CERTIFICATE OF APPROPRIATENESS

Property: 600 Avondale Street, Lot 5, Tract 4, Block 6, Montrose Subdivision. The property includes a historic two-story brick and wood frame single-family residence and a detached garage apartment situated on a 9,750 square foot (75' x 130') interior lot.

Proposal: Alteration – Windows

Basis for Issuance: HAHC Issued Certificate of Remediation

STAFF PHOTOS – AUGUST 9, 2016

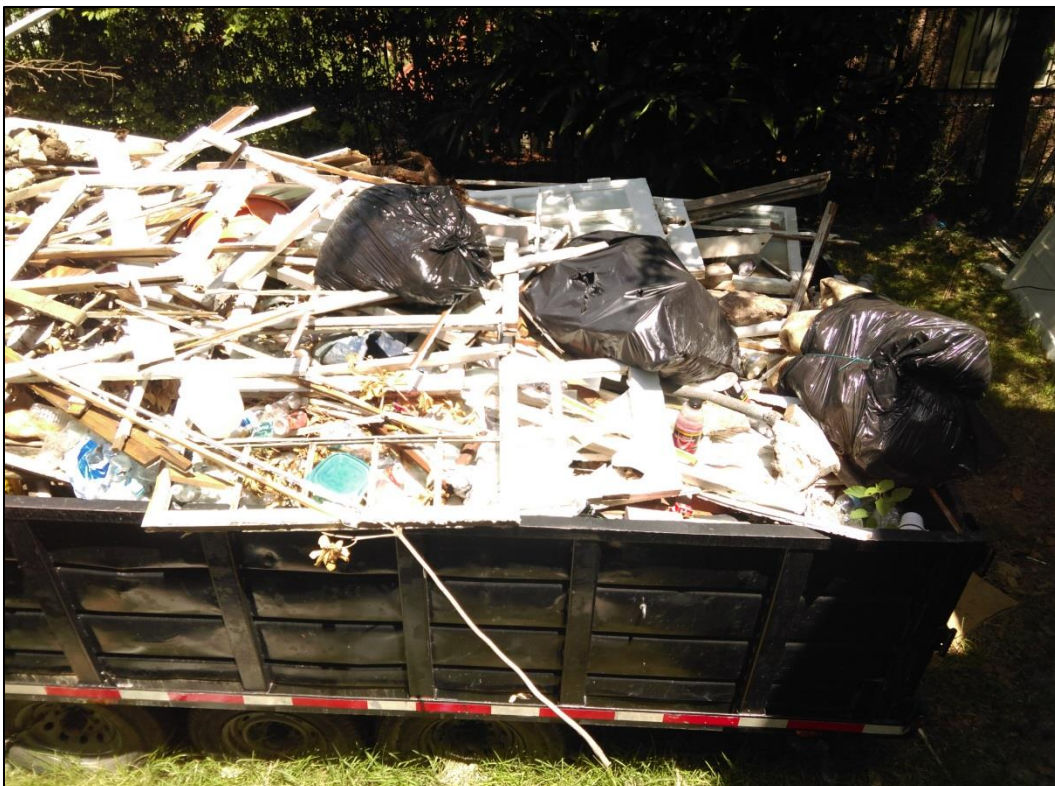
August 9, 2016: Staff revisited the site and found the original windows still located in a pile of construction debris. Several windows had been removed from the piles, but were left outside, propped against the house, and not protected from the elements. Because the applicants have not removed the other windows from the pile, staff is unable to determine whether they are salvageable.

WEST SIDE ELEVATION

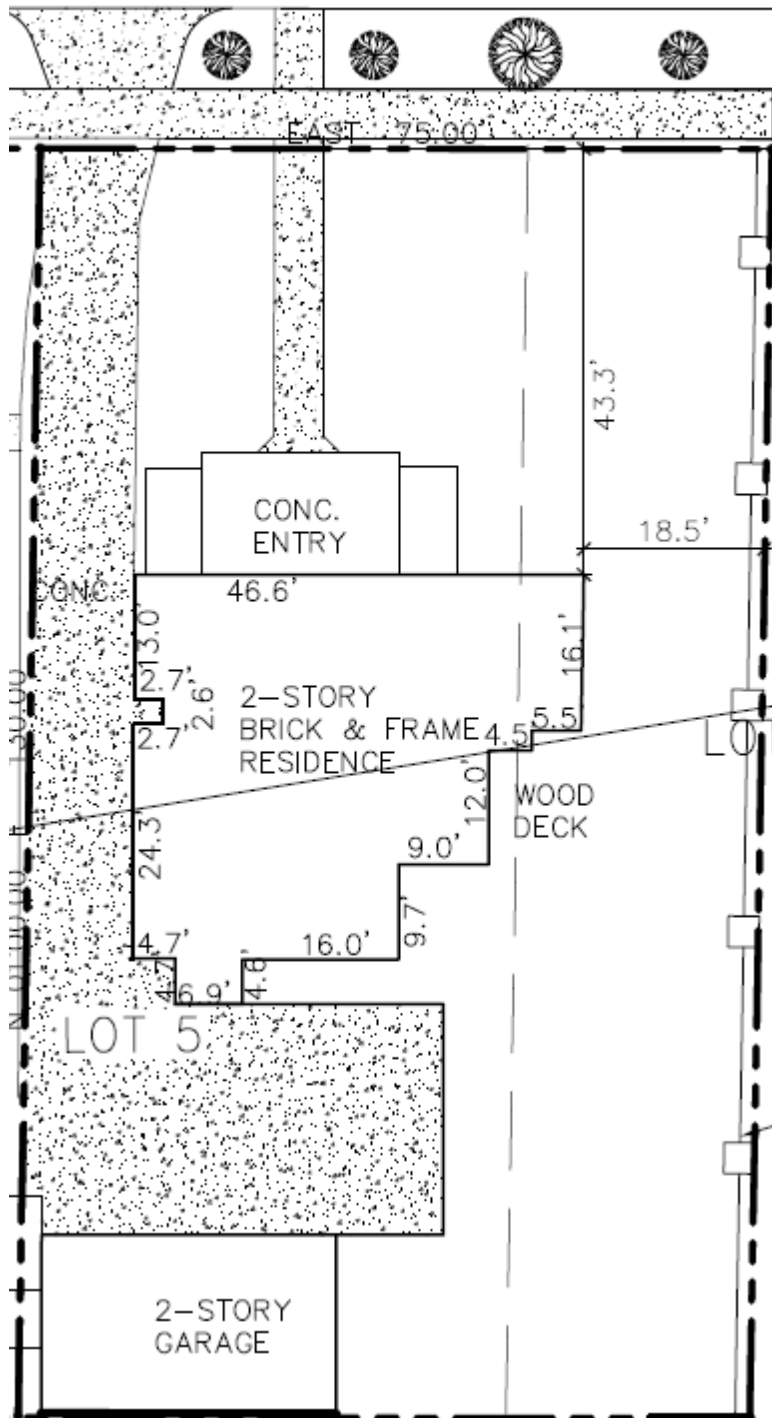
Original windows removed; proposed to be replaced with replica wood windows

Original windows removed; to be salvaged and reinstalled
